**TOWNSHIP OF NORTH DUMFRIES  
BUILDING DEPARTMENT**

These Plans have been examined for compliance with the Ontario Building Code requirements. A Building Permit has been issued, subject to any changes noted, under the condition that the building will be constructed in accordance with the code.

Tice River Homes  
Legacy

client: Tice River Homes  
location: Ayr  
project: Legacy  
marketing name:  
model: SD-01  
scale: 3/16" = 1'0"  
project #: 17052

page A1

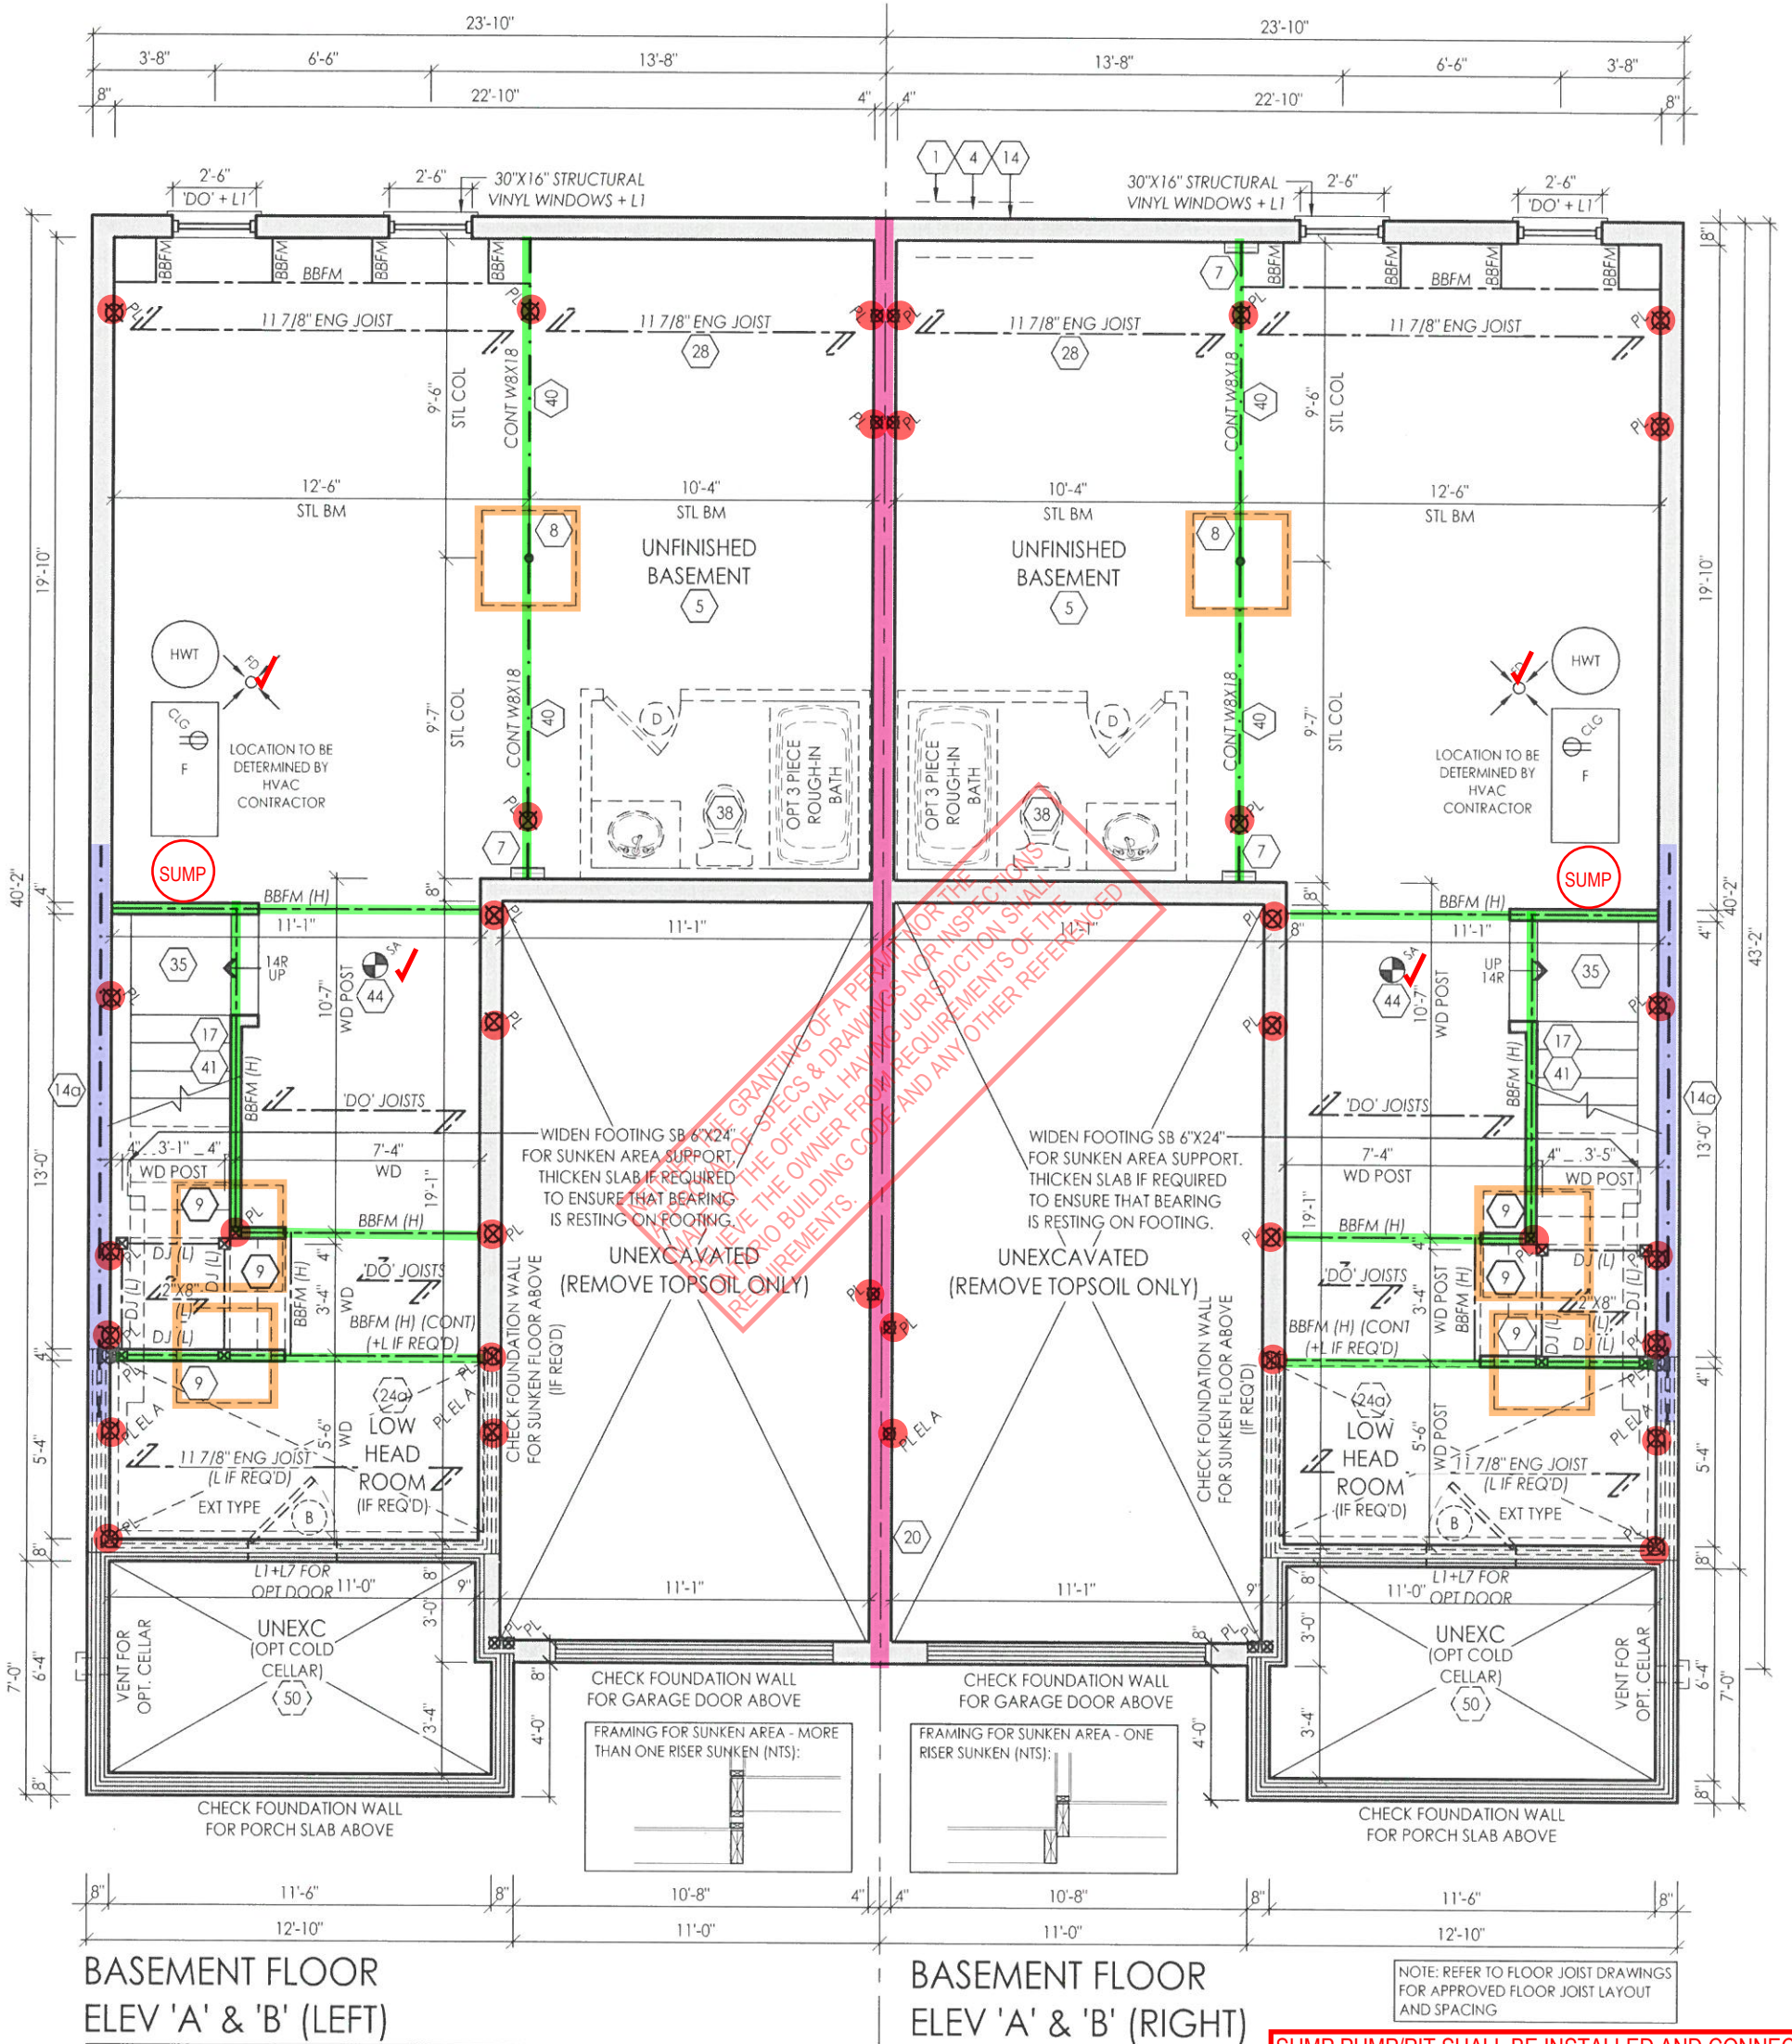
A FOUNDATION REBAR INSPECTION MUST BE PERFORMED PRIOR TO POURING FOUNDATION WALLS.

SOILS ENGINEER TO VERIFY ADEQUATE SOIL BEARING CAPACITY PRIOR TO FOOTINGS BEING POURED.

CALL FOR INSPECTION OF EXCAVATION CRIBBING BEFORE POURING ANY CONCRETE

DWELLING UNITS MUST BE SEPARATED BY CONSTRUCTION AND SOUND TRANSMISSION CLASSIFICATION OF AT LEAST 50 STC.

THE COLD CELLAR DOOR NEEDS TO BE INSULATED AND WEATHER-STRIPPED.

SUMP PUMP/PIT SHALL BE INSTALLED AND CONNECTED ACCORDING TO LOCAL REGULATIONS.

A5

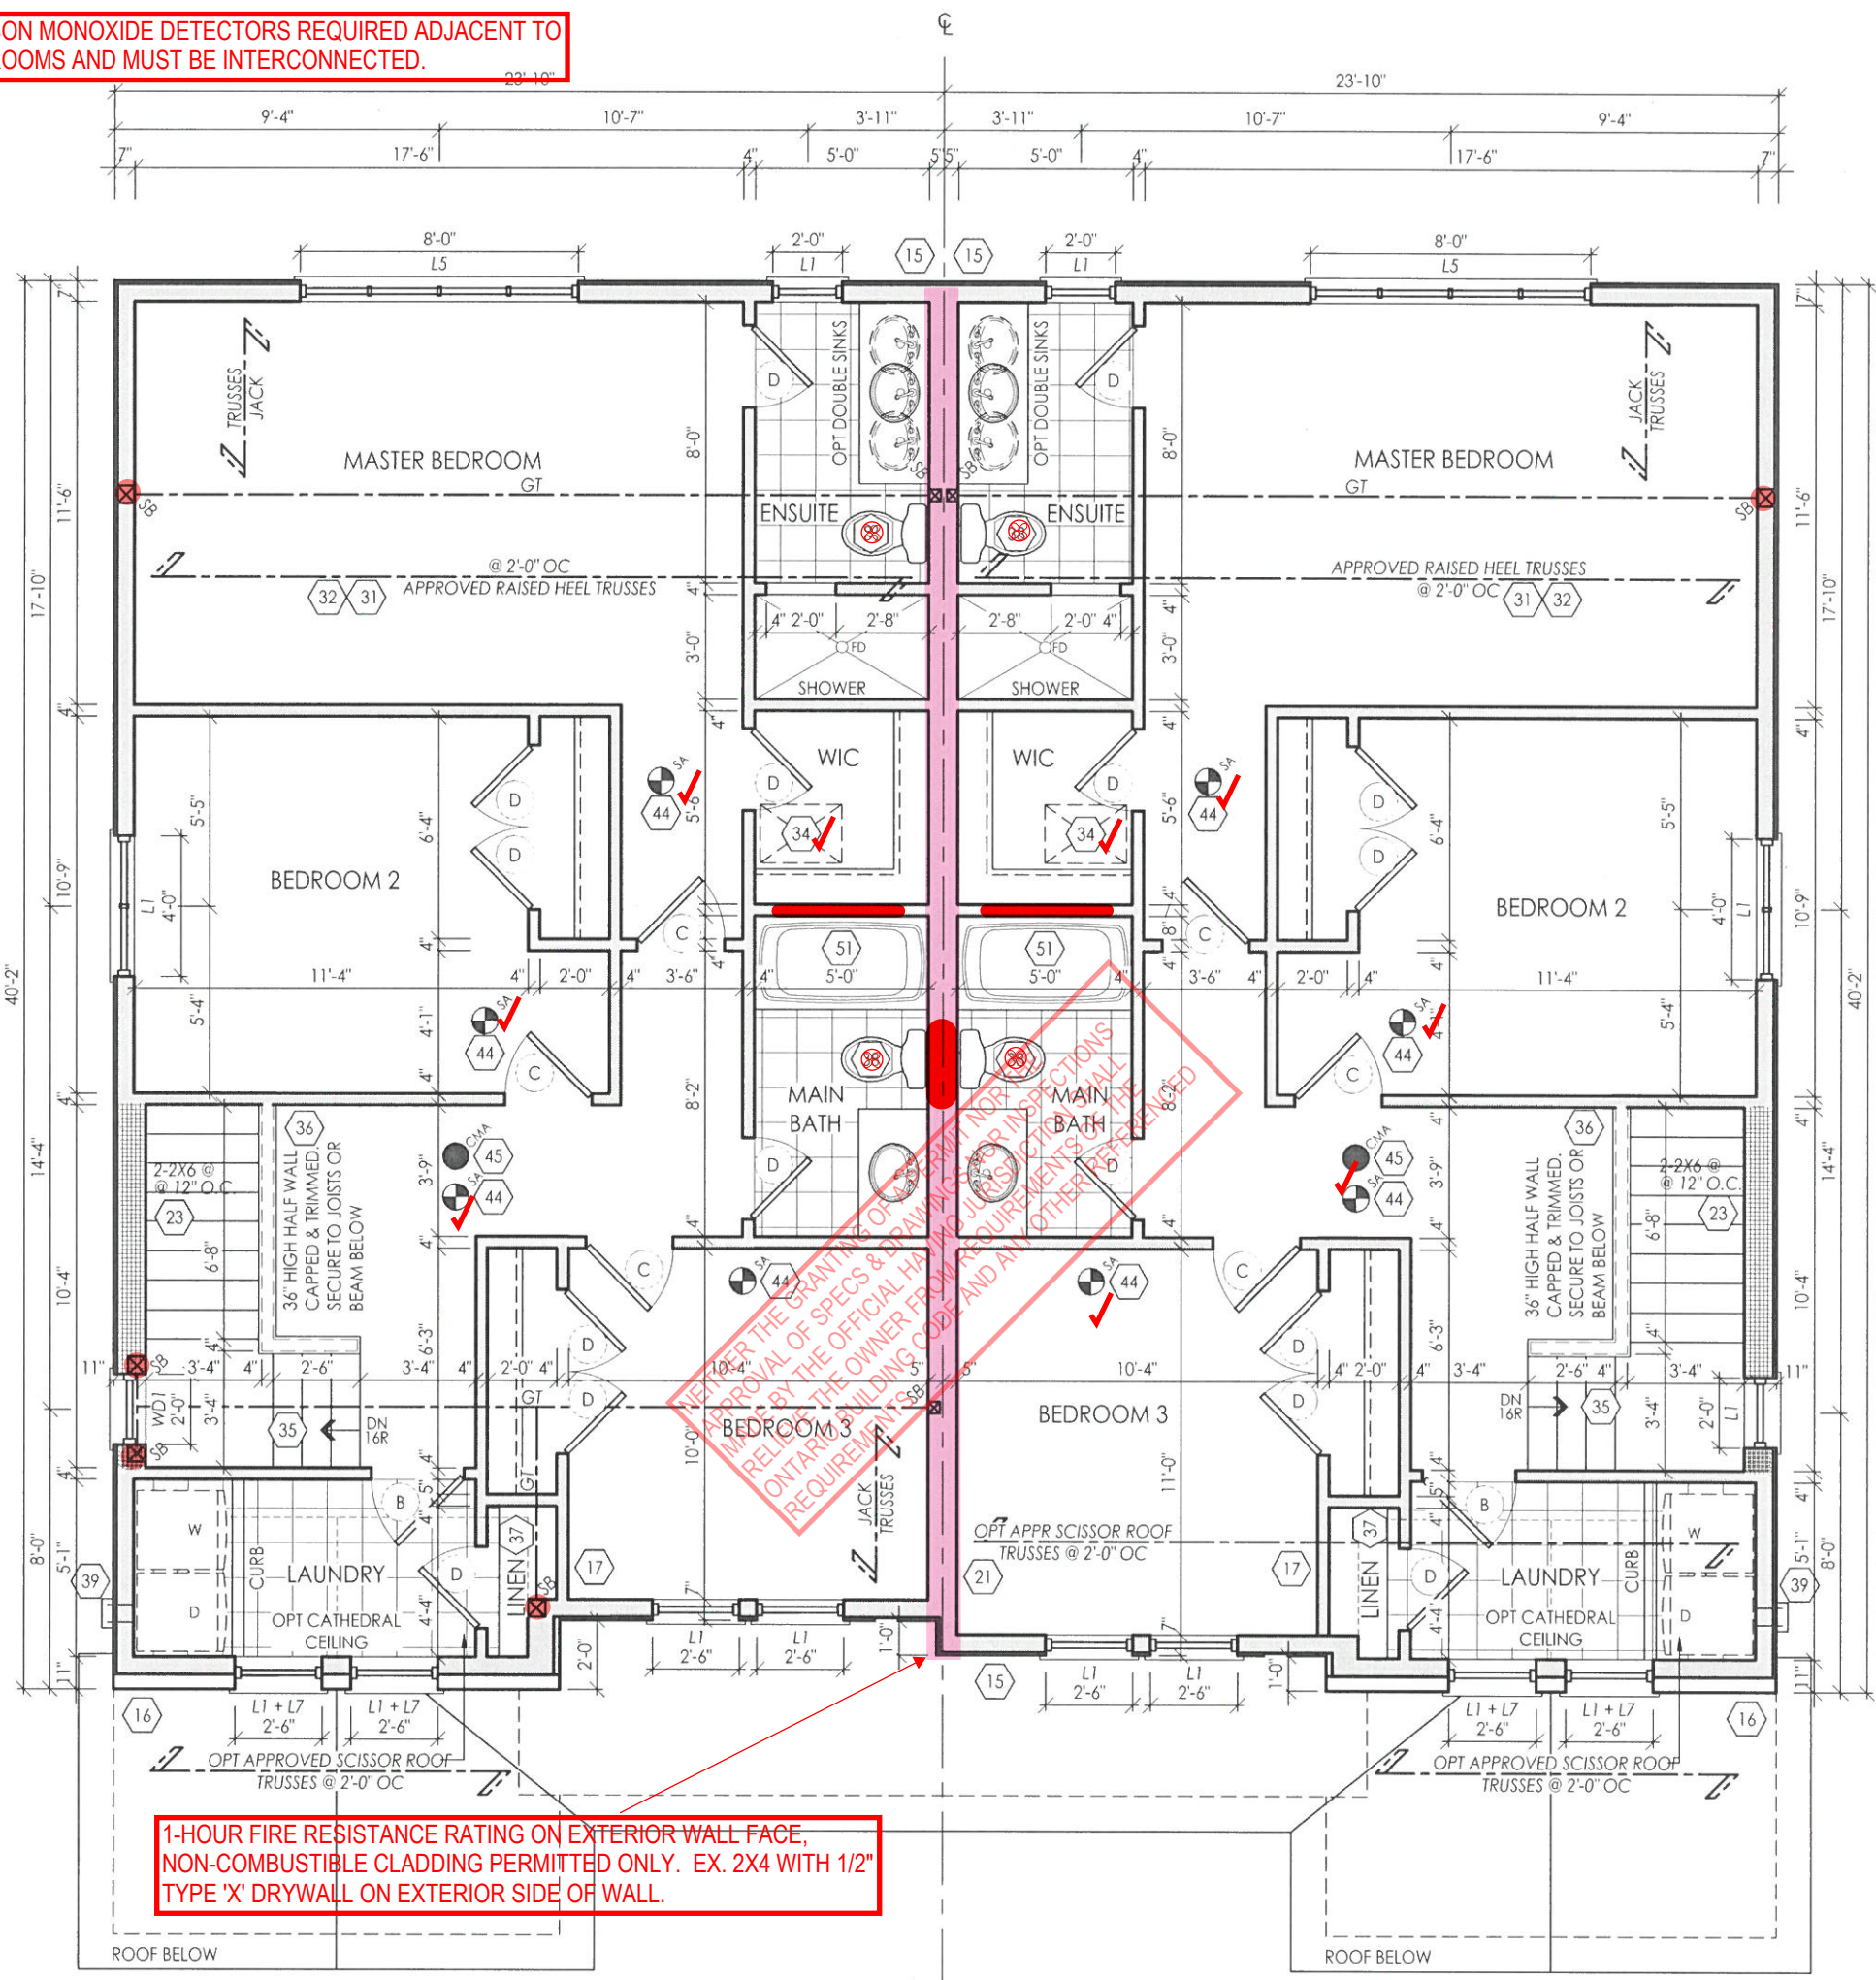
REINFORCEMENT IS REQUIRED FOR THE FUTURE INSTALLATION OF GRAB BARS FOR THE TOILET, SHOWER AND BATHTUB IN THE MAIN BATHROOM AS PER OBC 3.3.4.9.

SMOKE DETECTORS MUST BE INTERCONNECTED AND SHALL HAVE SINGALONG (STROBE) IN CONFORMANCE WITH 9.10.19.3. OR 3.2.4.22 OF THE OBC.

CARBON MONOXIDE DETECTORS REQUIRED ADJACENT TO BEDROOMS AND MUST BE INTERCONNECTED.

1-HOUR FIRE RESISTANCE RATING ON EXTERIOR WALL FACE, NON-COMBUSTIBLE CLADDING PERMITTED ONLY. EX. 2X4 WITH 1/2" TYPE 'X' DRYWALL ON EXTERIOR SIDE OF WALL.

AT LEAST 1 WINDOW SHALL PROVIDE AN UNOBSTRUCTED AREA OF 22" X 39" W/ A SILL HEIGHT MAX. 3'-3" ABOVE FINISHED FLOOR & 23'-0" ABOVE GRADE
